Swan_soundbar_DVT2_Assembly review v0.1

ALT Co., Ltd.

Issued Date 2021.05.11

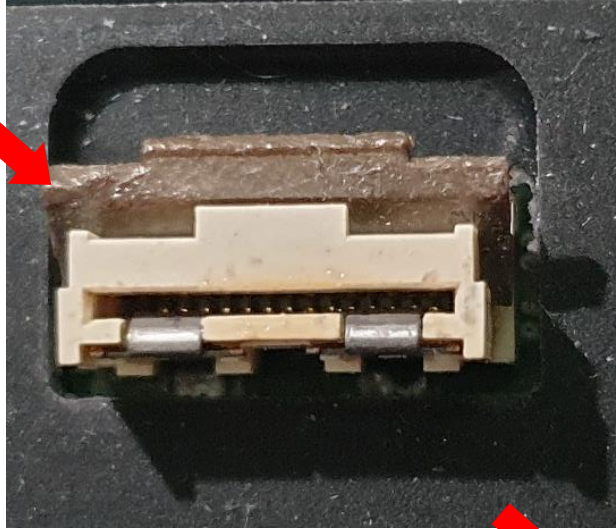
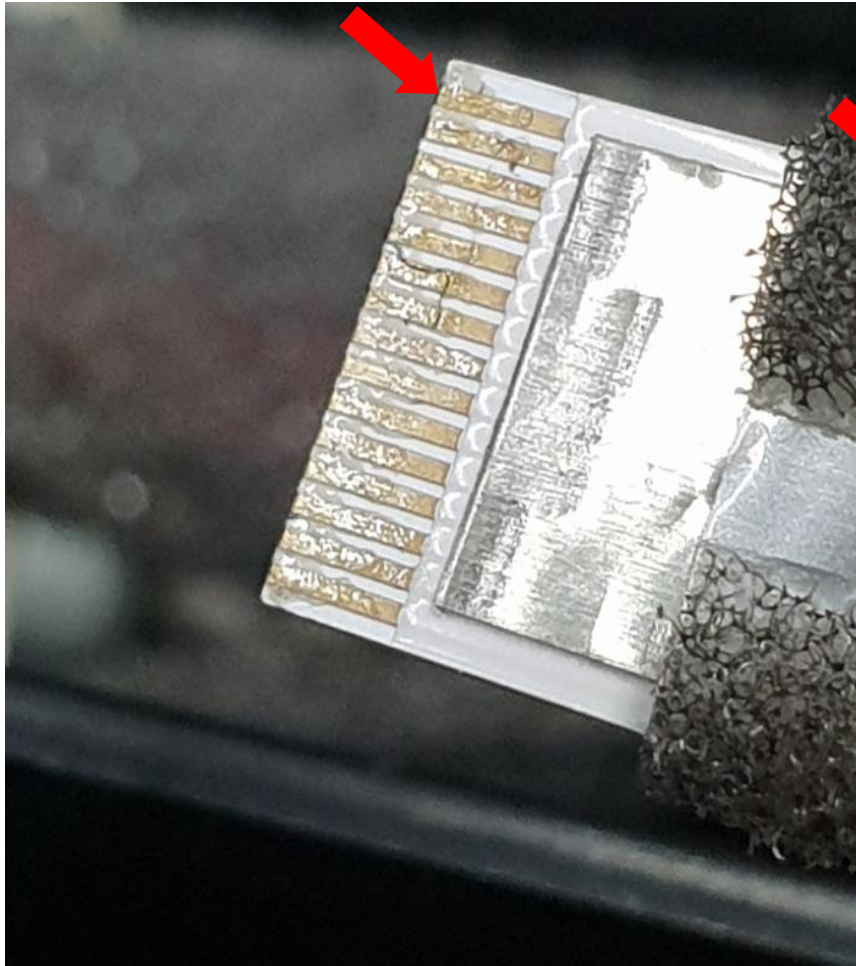
- PCB/FFC contamination

NG

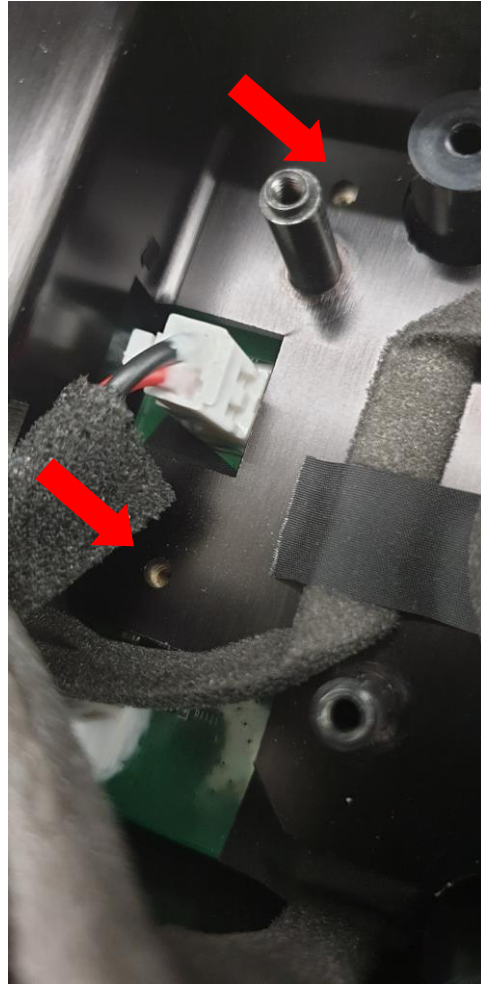
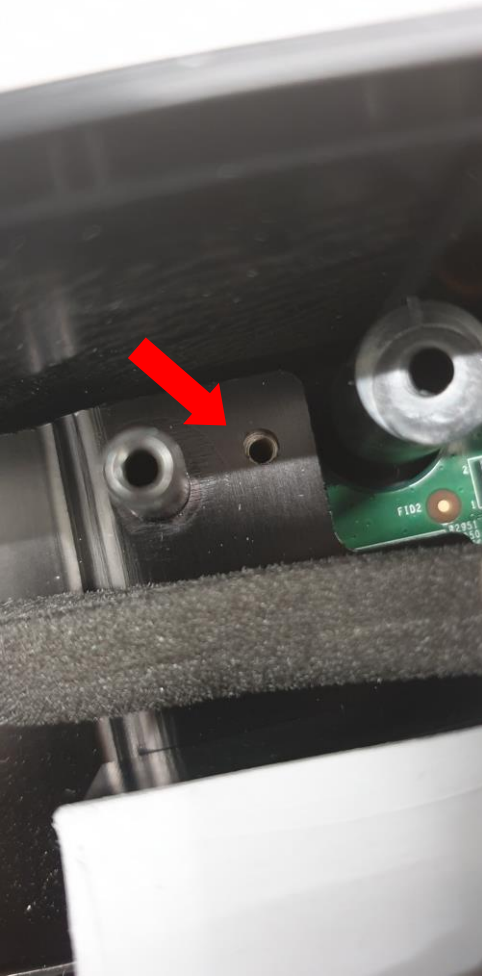
- AMP Bottom heat spreader screws are not fastened.

- ALT Comment
 - If inner structure is not fastened, can be make vibration noise
 - Please update Fii SOP as a CTQ

NG

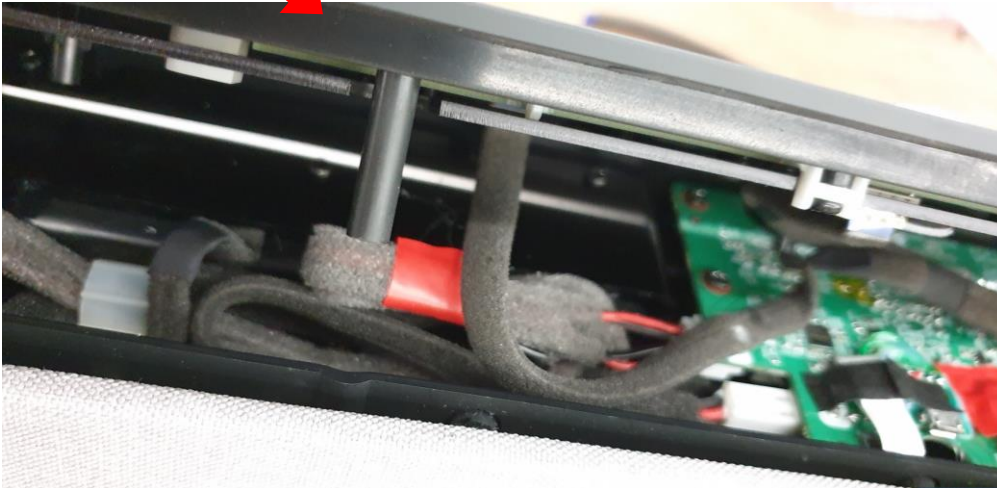
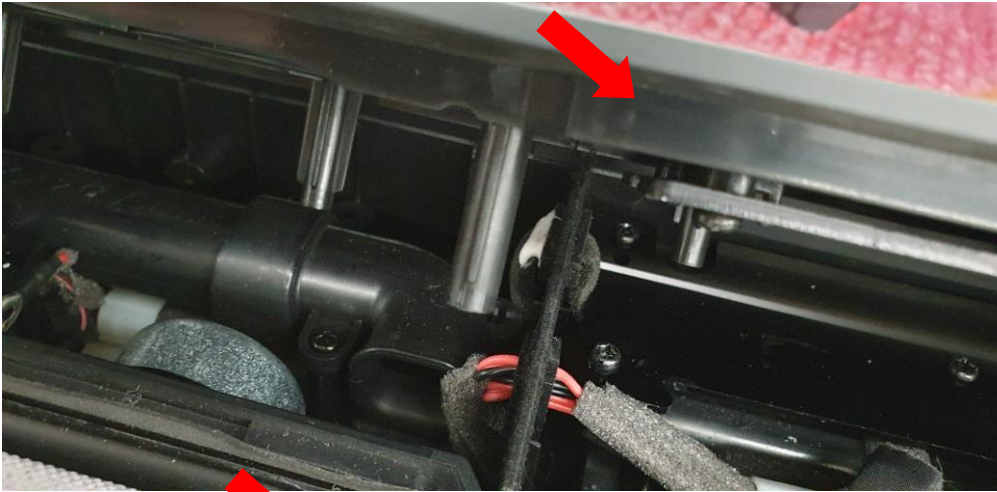
- Top Gasket is missing

NG

- ALT Comment
 - Top gasket is critical to quality (CTQ) to prevent air leakage.
 - Please update Fii SOP as a CTQ

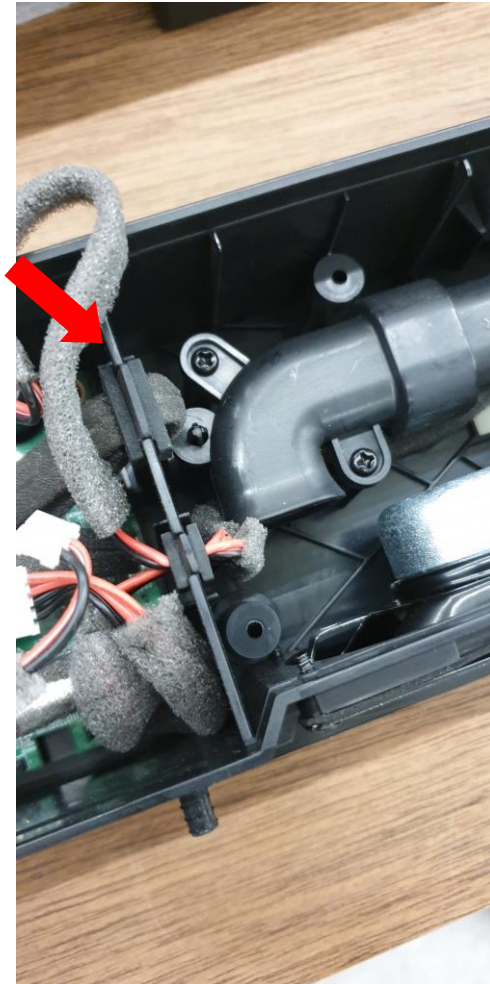
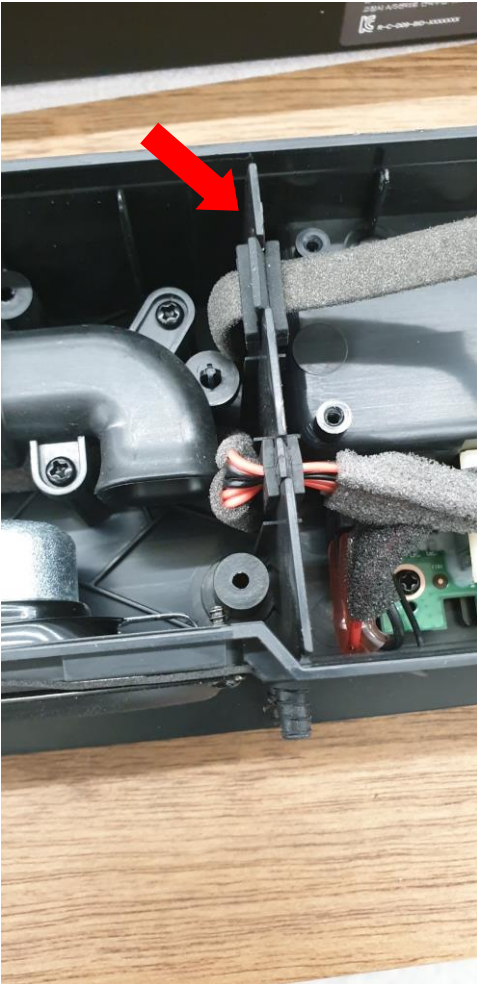
- Inner Gasket is missing

- ALT Comment
 - Top gasket is critical to quality (CTQ) to prevent air leakage.
 - Please update Fii SOP as a CTQ

NG

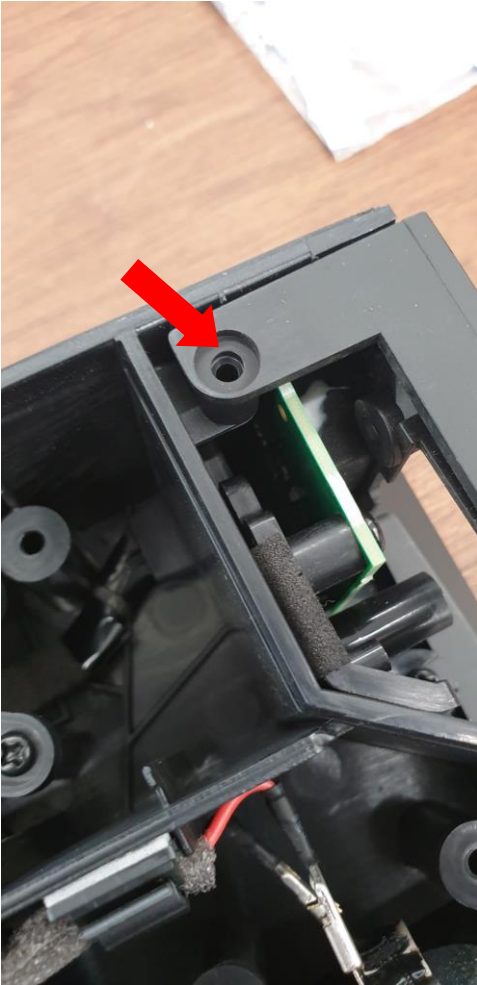
- Screw is missing

- ALT Comment
 - If inner structure is not fastened, can be make vibration noise
 - Please update Fii SOP as a CTQ

NG
